GROUP CLI	MODEL 2022MY Stinger (CK) w/3.3L T-GDI
	NUMBER 050	DATE May 2021

TECHNICAL SERVICE BULLETIN

**SUBJECT: SERVICE ACTION: HEATER HOSE CLAMP INSPECTION
AND REPLACEMENT (SA479)**

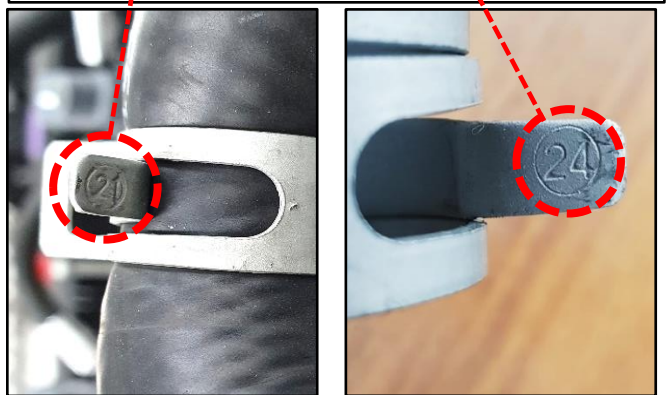
2. Locate the heater hose (A) and confirm the correct hose clamp(s) size stamping is found on opposite ends as shown.

- If the $\text{\O}24$ is found on the end requiring the $\text{\O}21$ size hose clamp, proceed to the '**Replacement Procedure**' outlined below.

- If the $\text{\O}24$ and $\text{\O}21$ hose clamps are found to be correctly installed in their corresponding ends, no further action is required. Reinstall the engine cover.

**Replacement Procedure:**

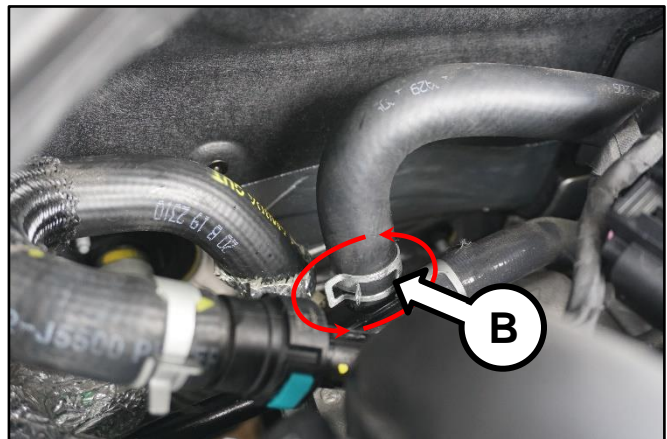
This bulletin provides the procedure to inspect and if necessary, replace the heater hose clamp on some 2022MY Stinger (CK) vehicles equipped with 3.3L T-GDI LAMBDA II engine, which may have had the incorrect diameter hose camp installed in one of the hose ends during assembly. The larger Ø24 diameter hose clamp may cause the heater hose to leak coolant. To correct this concern, replace the Ø24 with the correct Ø21 hose clamp. Before conducting the procedure, verify that the vehicle is included in the list of potentially affected 47 VINs.

1. Using a set of pliers, turn the heater hose clamp (B) counterclockwise. Remove the $\text{\O}24$ clamp.
2. Install the correct $\text{\O}21$ hose clamp.
3. Confirm normal vehicle operation and no leaks are present.
4. Reinstall the engine cover.
